Application No. 09/437,418

VERSION WITH MARKINGS TO SHOW CHANGES MADE

SENSOR PACKAGE FOR FLUSH MOUNTING OF A SENSOR

FIG. 5

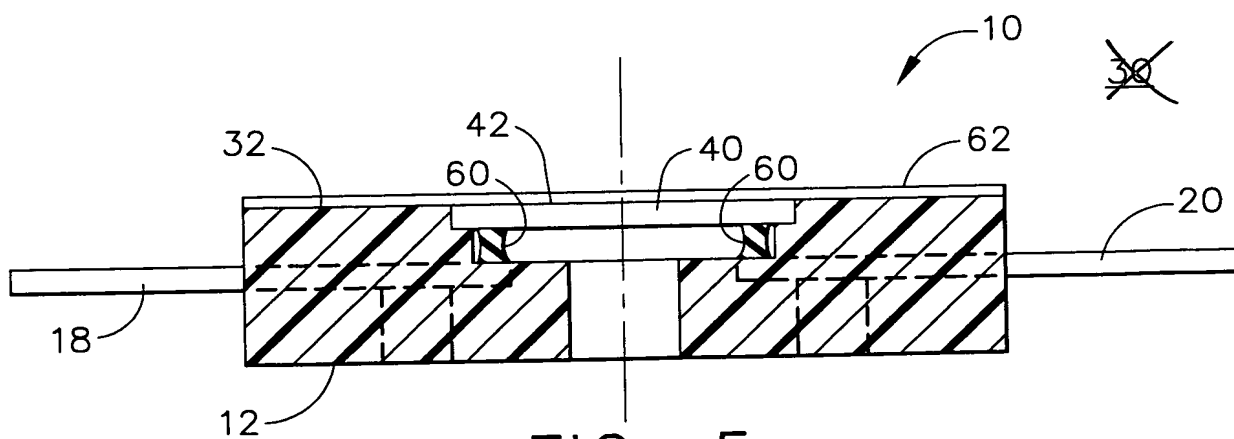
Figure 5 has been amended as follows:

With the concurrence of the Examiner, applicants intend to amend Figure 5 of the Drawing by deleting the reference numeral "30" therefrom as shown by the red ink notation on the accompanying copy of Figure 5.
